ADDENDUM NO. 2

FOR
Phase 1 - Renovation
Lincoln
Middle / High School
205 E. Parkway Dr.
Cambridge City, IN 47327
PROJECT 2356-1

AREA "A"
DEMOLITION FLOOR
PLAN
SCALE: 1/8" = 1'-0"

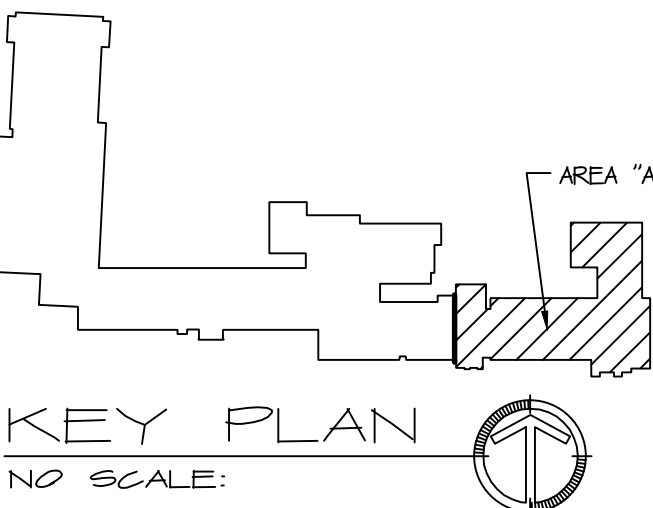
- See revised D1.1 2/5/2024 with revised asbestos notes.

ASBESTOS NOTE:

1. E.G. TO REMOVE ASBESTOS NON-FRIABLE FLOOR TILE AND ADHESIVE IN COMPLIANCE WITH ALL LOCAL, STATE, AND FEDERAL REQUIREMENTS. REMOVAL IN A MANNER COMPATIBLE WITH NEW FLOOR FINISH AND ADHESIVE. COORDINATE WITH OWNER.
2. PROVIDE A UNIT COST PER 100 SF. OF ASBESTOS FLOOR TILE REMOVAL FOR ANY DISCOVERED DURING CONSTRUCTION. SEE BID FORM.
